Product Change Notice (PCN)

PCN Number: **PCN-0451089R-01**

Product(s) Affected: *PJ-041-SMT-TR*

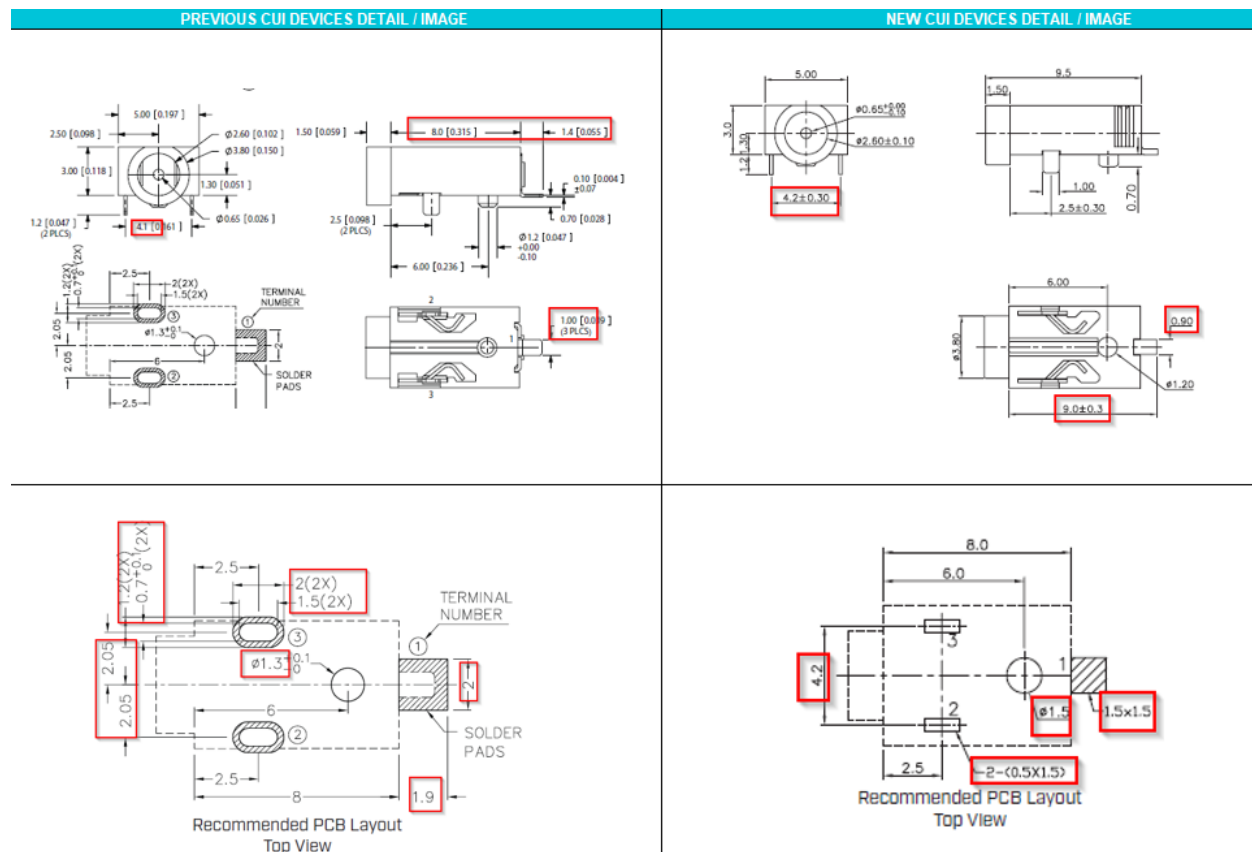
Description of Change: *Minor Housing and footprint differences. Material Change on the housing and terminals. PCB pad sizes, spacings differ. New part will fit on previous footprint. See image Below*

PREVIOUS CUI DEVICES DETAIL / IMAGE			NEW CUI DEVICES DETAIL / IMAGE		
	MATERIAL	PLATING	DESCRIPTION	MATERIAL	PLATING/COLOR
center pin	copper	nickel	center pin	bronze	silver
terminal 1	brass	silver	terminal 1	bronze	silver
terminal 2	copper alloy	silver	terminal 2	SUS301 t=0.20	gold
terminal 3	copper alloy	silver	terminal 3	SUS301 t=0.20	gold
plastic	PAST or equivalent		housing	PA10T (UL94V-0)	black
